Supplemental Safety Evaluation
For The
General Electric Topical Report
Qualification Of The One-Dimensional
Core Transient Model For
Boiling Water Reactors
NEED-24154 and NEDE-24154P
Volumes I, II and III

Reactor Systems Branch, DSI

Figure 2-1. 5% Significance Coefficient (A) vs. Surveillance Data in Cycle

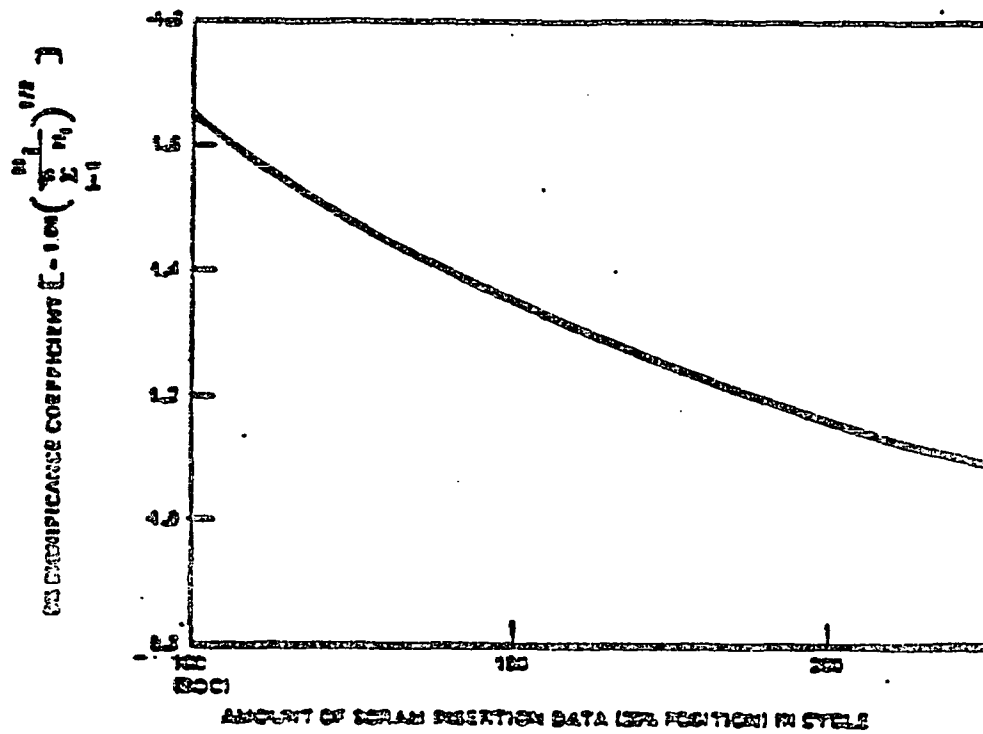
The relationship between the coefficient, λ , and the amount of surveillance data generated during the cycle is illustrated in Figure 2-1. As more data become available through the performance of in-cycle surveillance tests, the coefficient decreases, as does the acceptance criterion, τ_2 . Thus, the screen speed criterion is being tightened as the cycle progresses, based on the assumption that, as more screen data become available during the cycle, the uncertainty in the mean value calculation should decrease.

We find the screen insertion time conformance procedure to be acceptable.
